6/12/78	Revised 6th and 7th line of Legend
DATE	REVISION
STATE OF HAWAII DEPARTMENT OF TRANSPORTATION HIGHWAYS DIVISION	
KEEHI INTERCHANGE ELECTRICAL PLAN - PART I	
INTERSTATE ROUTE H-1 PROJECT NO. I-HI-1(130):17	
SCALE: NONE	DATE: AUG. 16, 1976
SHEET No. E1 OF E12 SHEETS

8/3/77	RELOCATED COLUMN MOUNTED LUMINAIRE FOR AT GRADE ROADWAY FROM RAMP II TO RAMP I
DATE	REVISION
STATE OF HAWAII DEPARTMENT OF TRANSPORTATION HIGHWAYS DIVISION	
KEEHI INTERCHANGE ELECTRICAL PLAN - PART II STAGE II CONSTRUCTION	
INTERSTATE ROUTE H-1 PROJECT NO. I-HI-1 (130):17	
SCALE: N.T.S.	DATE: AUG. 16, 1976
SHEET NO. 52 OF 52 SHEETS

8/3/77	RELOCATED UNDERGROUND RACEWAY AND RUN-UP AT COLUMN FROM RAMP II TO RAMP I
DATE	REVISION
STATE OF HAWAII DEPARTMENT OF TRANSPORTATION HIGHWAYS DIVISION	
KEEHI INTERCHANGE ELECTRICAL PLAN - PART III STAGE II CONSTRUCTION	
INTERSTATE ROUTE H-1 PROJECT NO. I-HI-1(130):17	
SCALE: 1" = 50'	DATE: AUG. 16, 1976
SHEET No. E3 OF 12 SHEETS

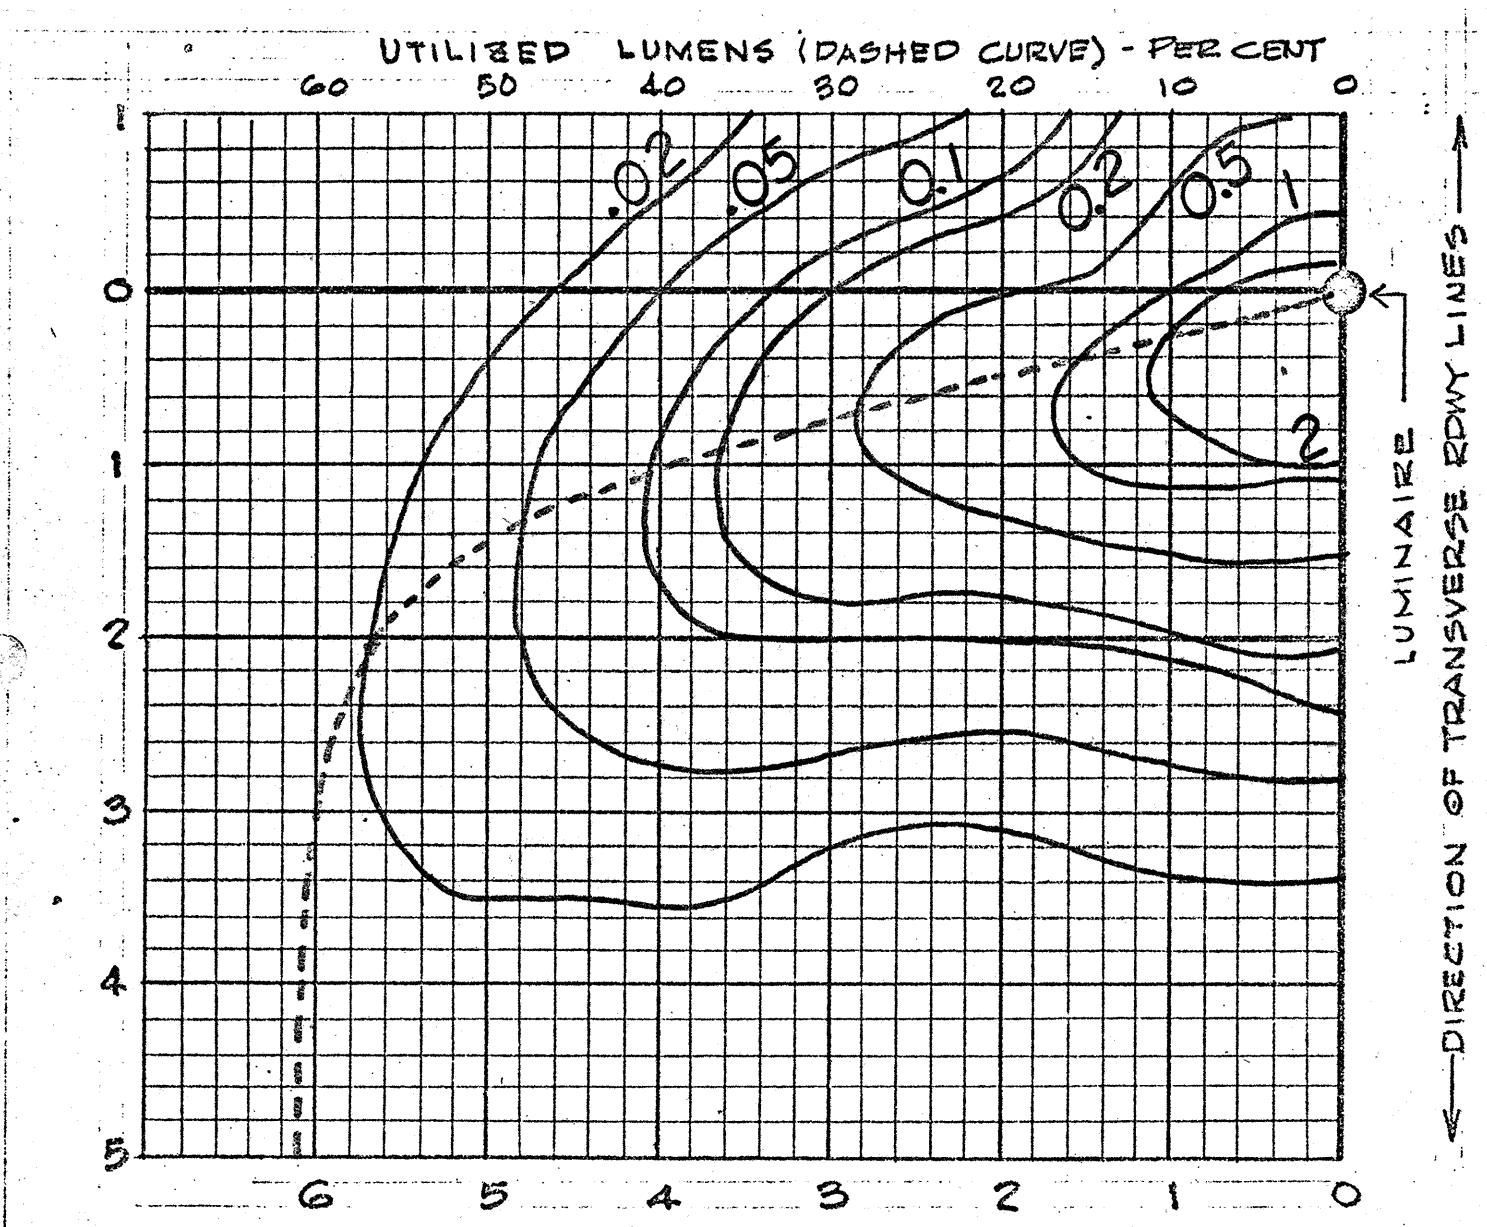
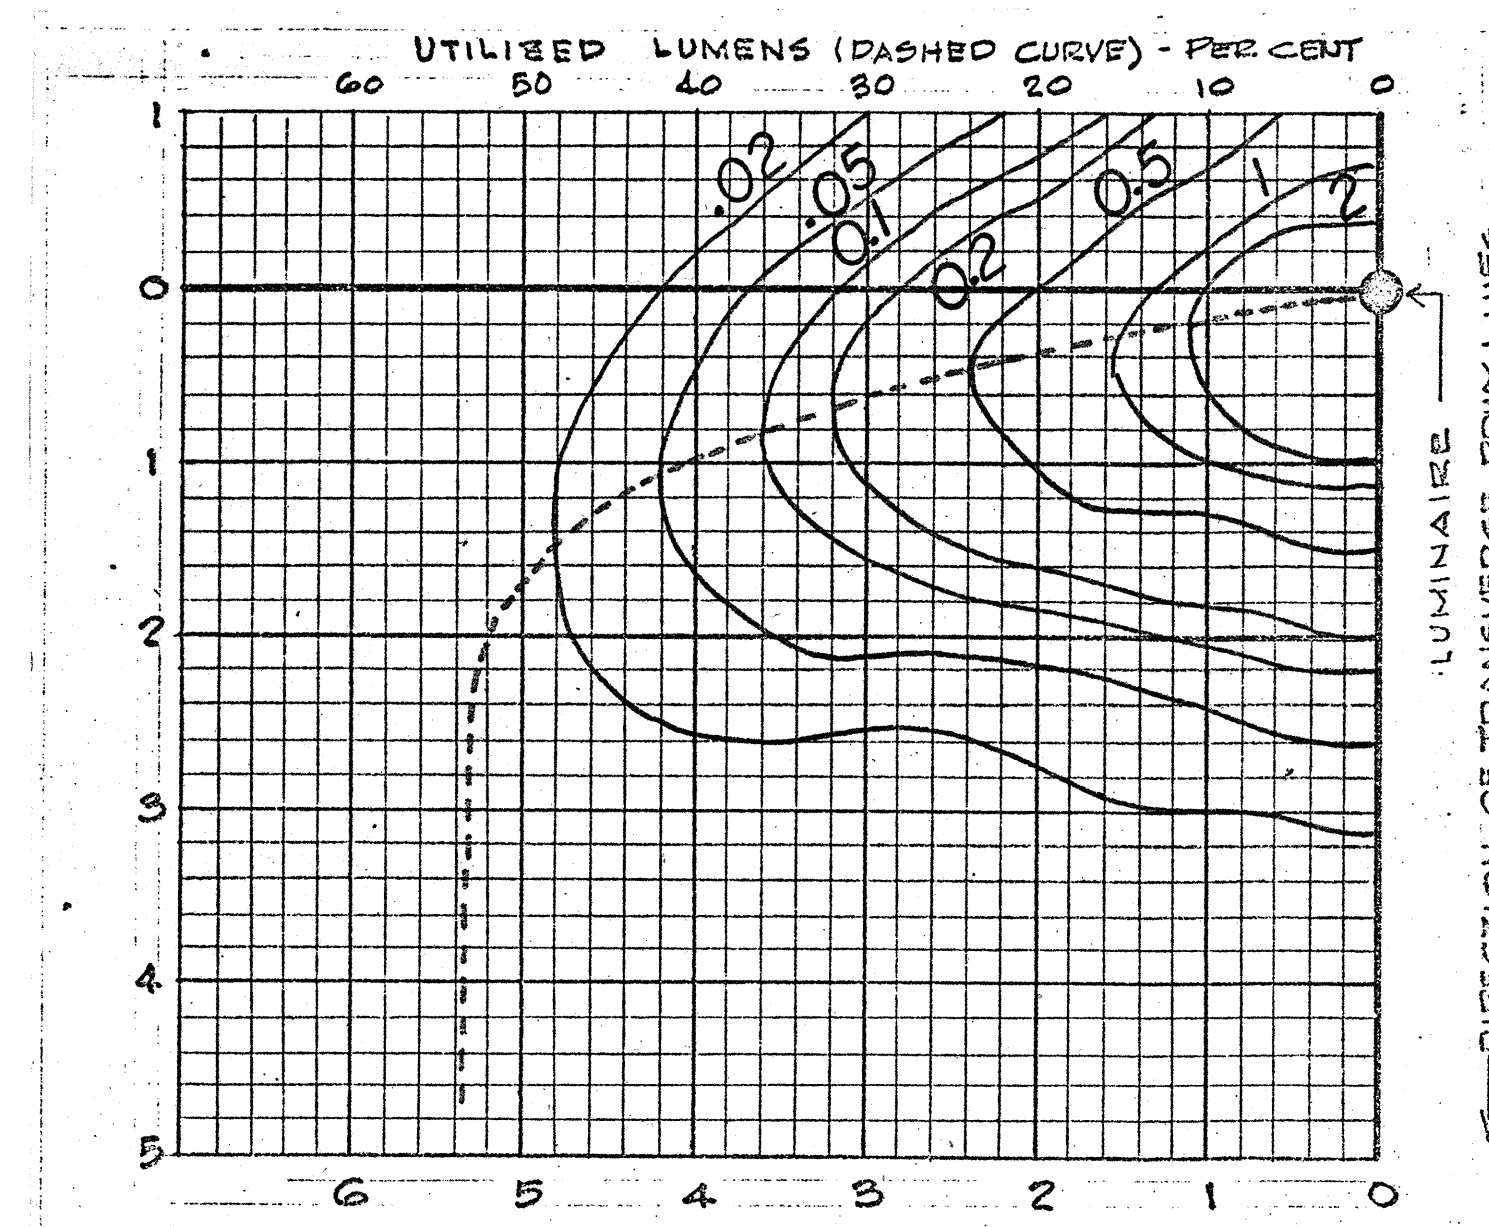
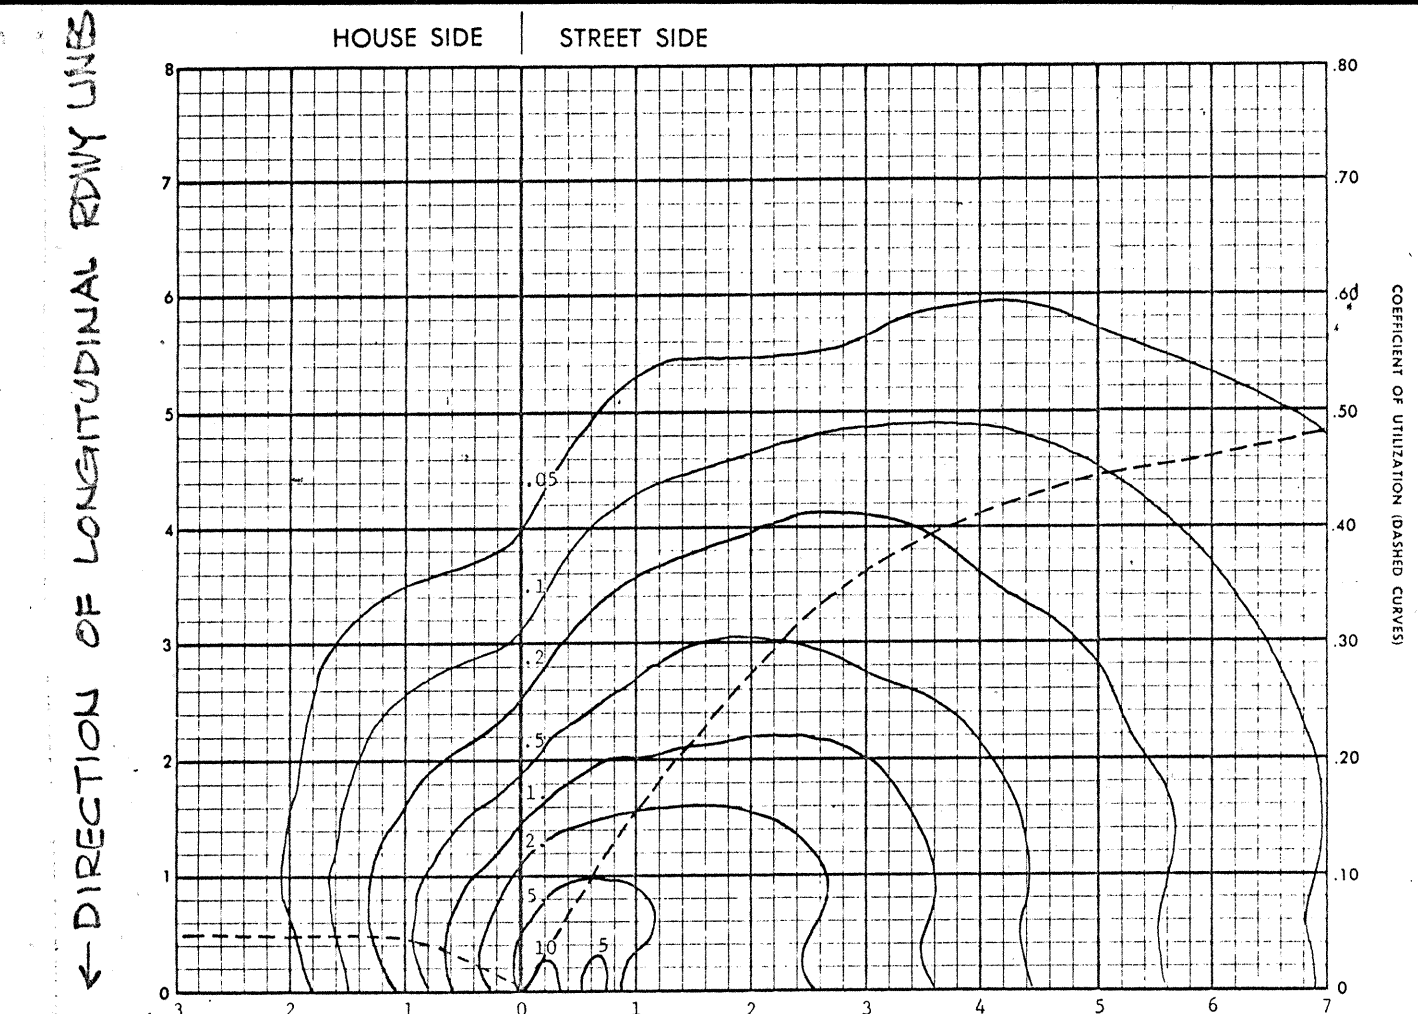
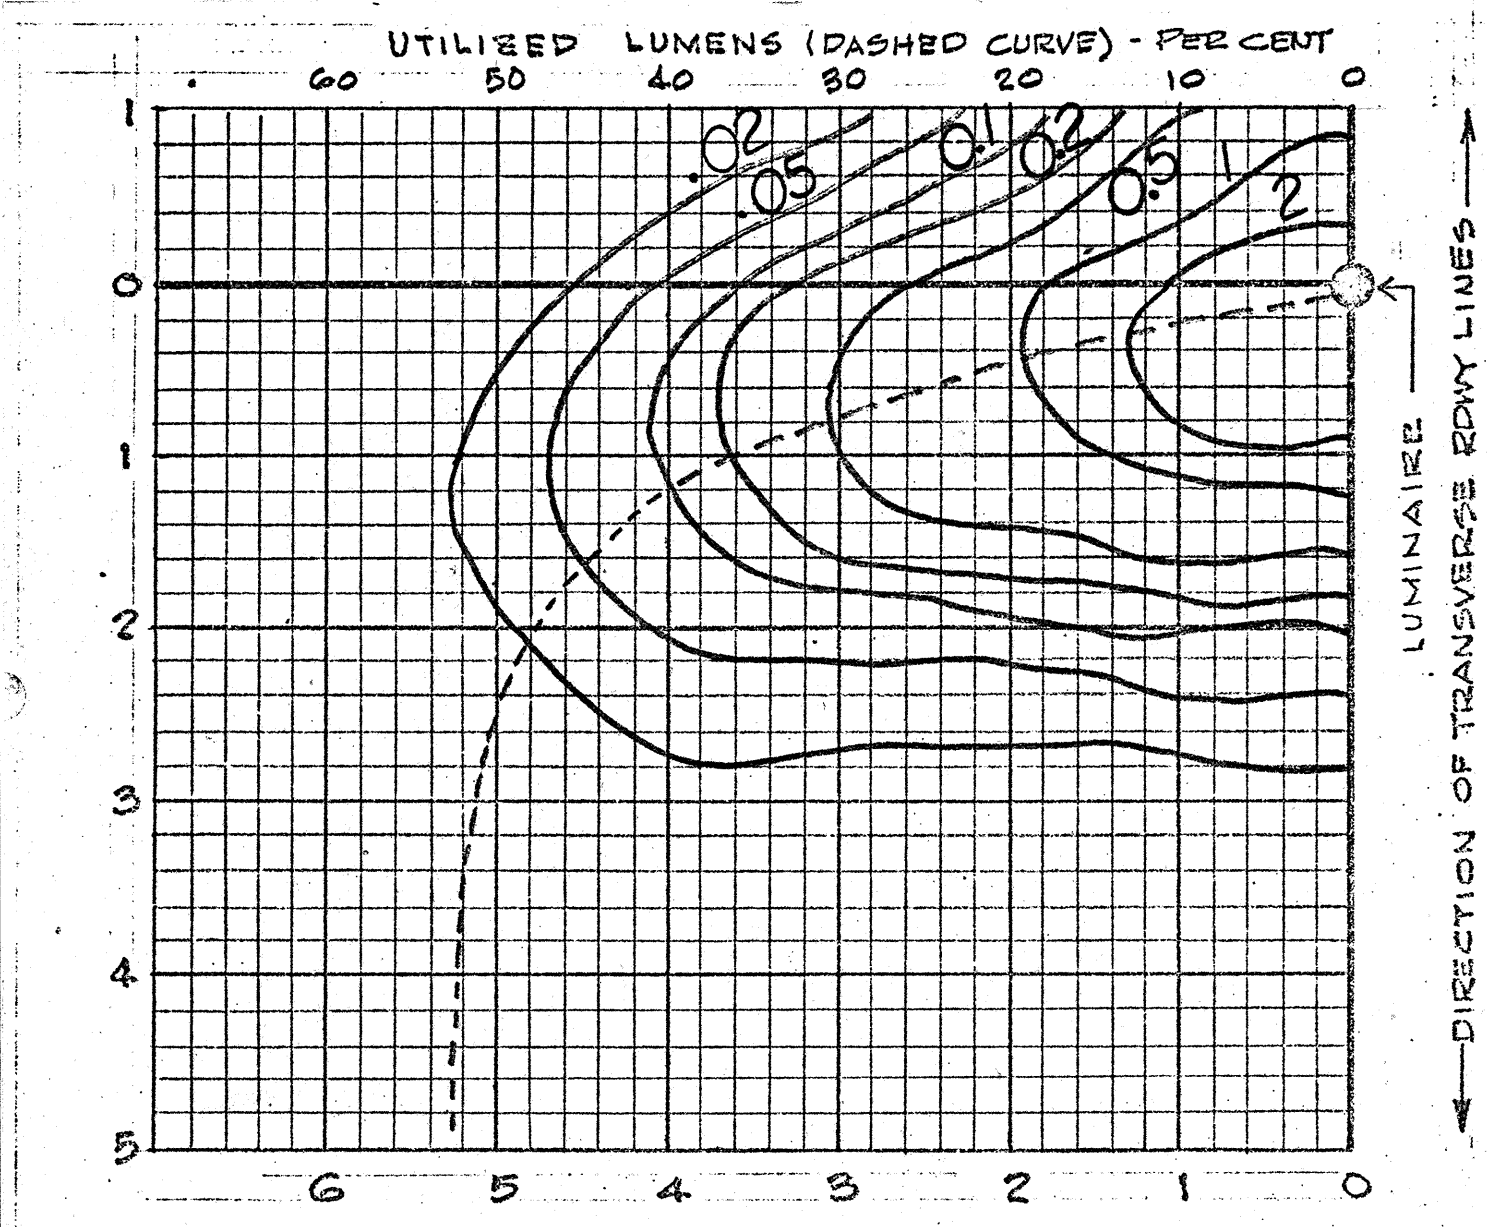
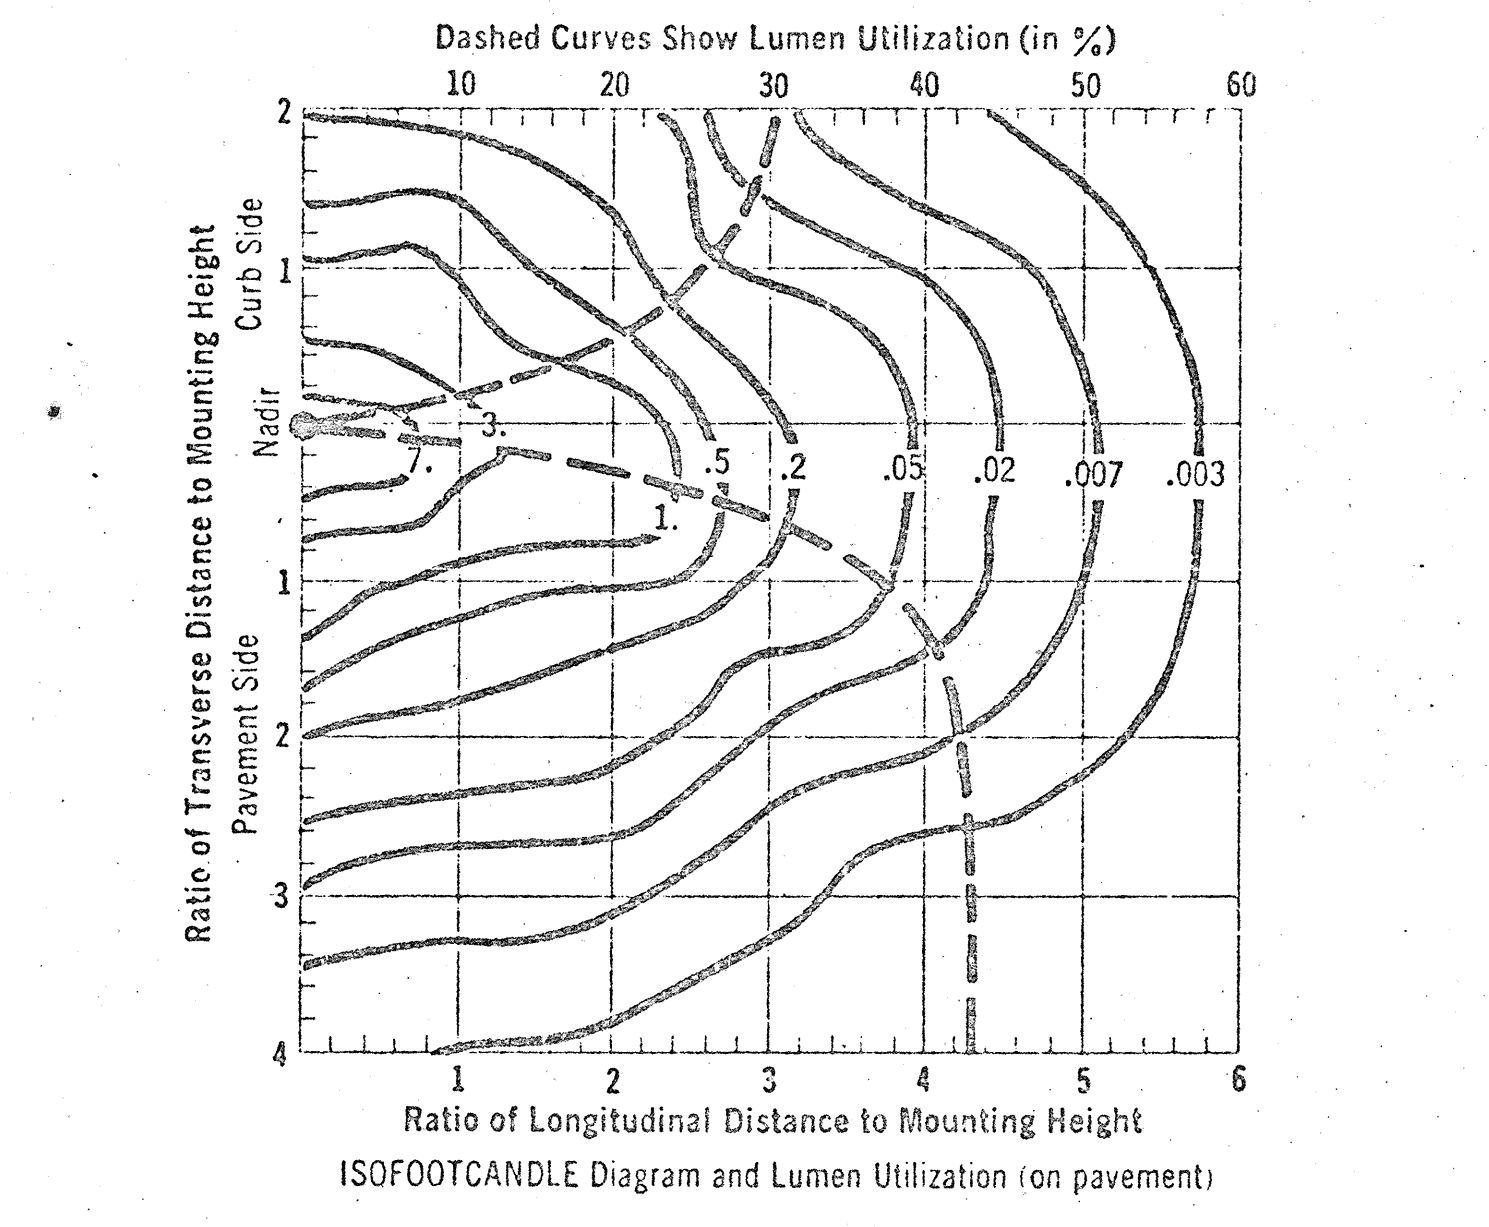
6/12/78	Revised Details 3/E5 and 6/E5
10/20/76	Removed Note 1. Revised dimensions of luminaires.
DATE	REVISION
STATE OF HAWAII DEPARTMENT OF TRANSPORTATION HIGHWAYS DIVISION KEEHI INTERCHANGE ELECTRICAL PLAN - PART V INTERSTATE ROUTE H-1 PROJECT NO. I-HI-1(130):17 SCALE: NONE DATE: AUG.16,1976 SHEET No. E5 OF 12 SHEETS
